10/695,400

Office Action Summary

DETAILED ACTION

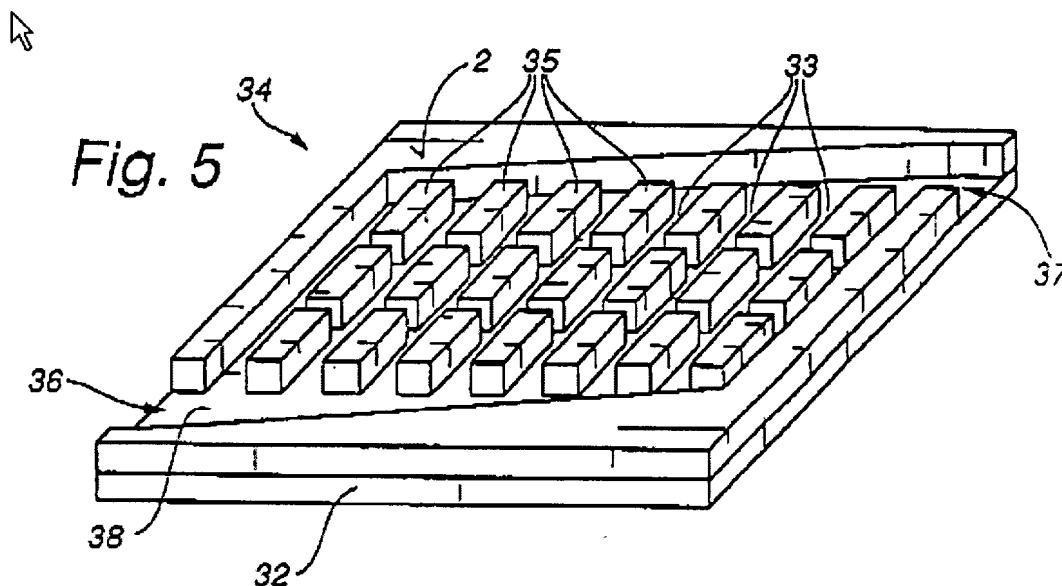
Fuesser teaches a microcooling device. The method comprises flowing a first fluid stream into a manifold and then through a first channel in a first direction and flowing a portion of the first fluid stream to a second channel. The second channel extends at a nonzero angle relative to the first direction. (See Figure 5) The second channel comprises a microchannel and comprises at least one dividing wall that separates the second channel into at least a first and a second subchannel. The first layer and the manifold are each substantially planar. (See Figure 5) The manifold is substantially contained within the first layer. The first layer and the manifold are substantially coplanar. (See Figure 5) The first channel is disposed in the first layer and flow through the first channel is substantially parallel to the plane of the first layer. The first channel and the manifold are about the same height. (See Figure 5) The

second layer is substantially planar and the second channel is disposed in the second layer and flow through the second channel is substantially parallel to the plane of the second layer. The first layer and the second layer are substantially parallel and the nonzero angle refers to an angle within the second layer. (See Figure 5)

Fuesser further teaches a plate comprising an opening is disposed between the first and second layers and flow from the first layer passes through the opening into the second layer. (See Figure 5) Additionally, Fuesser teaches the first layer comprises multiple adjacent parallel microchannels separated by channel walls and the second layer comprises multiple adjacent parallel microchannels separated by continuous channel walls. The continuous channel walls traverse the width of the multiple adjacent parallel microchannels in the first layer. (See Figure 5) The second layer is made from a sheet containing slots. It is inherent that the second layer tends to equalize flow through the multiple adjacent parallel microchannels in the first layer.
